22nd February 2019

**Development Application DA2018/1743
Supplementary Statement of Environmental Effects/
Amended clause 4.6 variation request – Height of buildings
Proposed shop top housing development
396 – 402 Sydney Road, Balgowlah**

**Amended Clause 4.6 variation request – Height of buildings
Proposed Shop top housing development
396 – 402 Sydney Road, Balgowlah**

Figure 1 – Height compliance diagrams

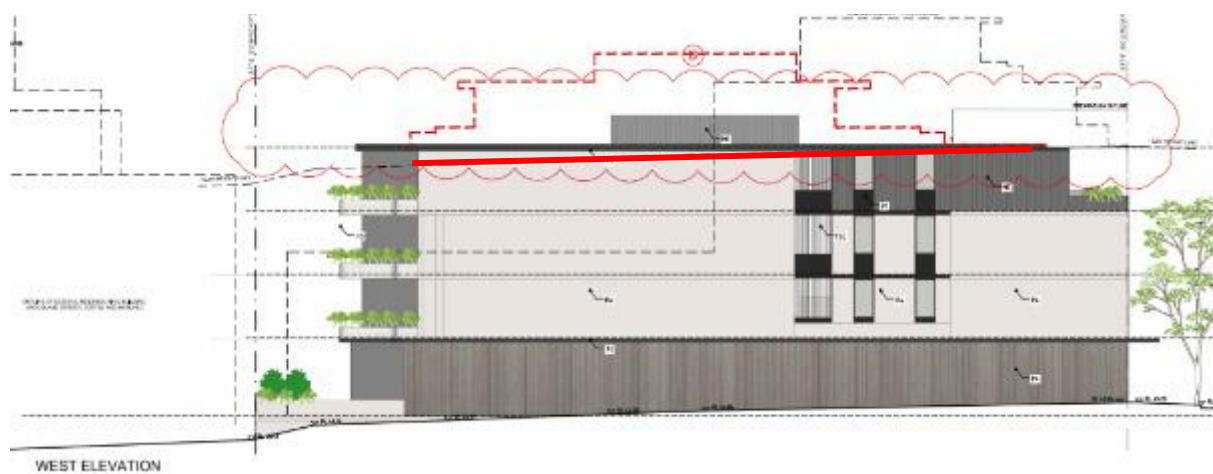
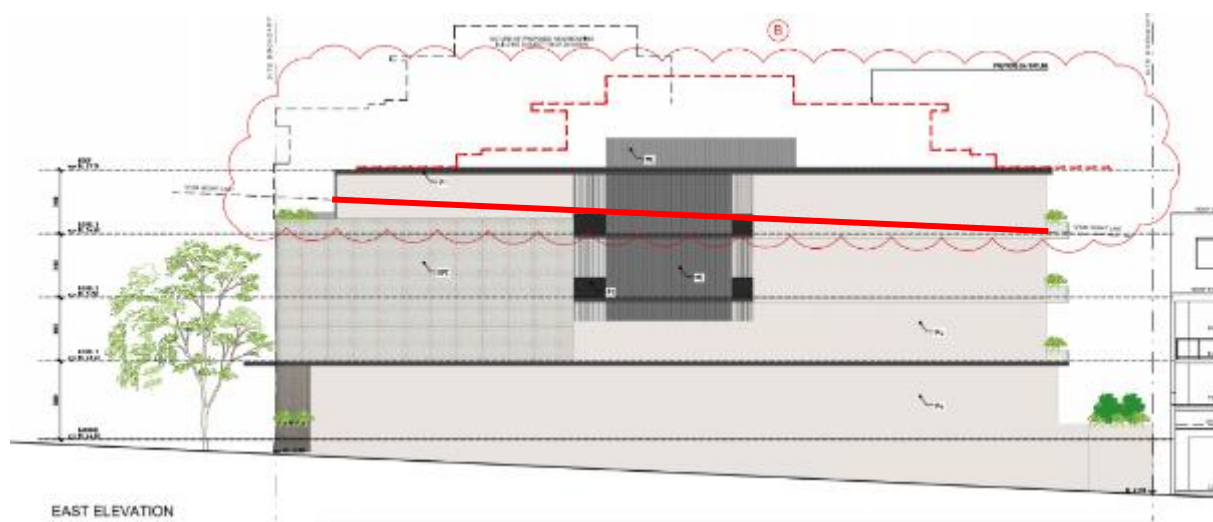
The amended development has a maximum building height of 15.7 metres measure to the north eastern roof edge above Unit 303 and the lift overrun beyond. This represents a variation of 3.2 metres or 25%. The variable extent of non-compliance is diagrammatically depicted in Figure 1 over page with the recently approved shop top housing development at No. 404 Sydney Road shaded for comparative analysis.
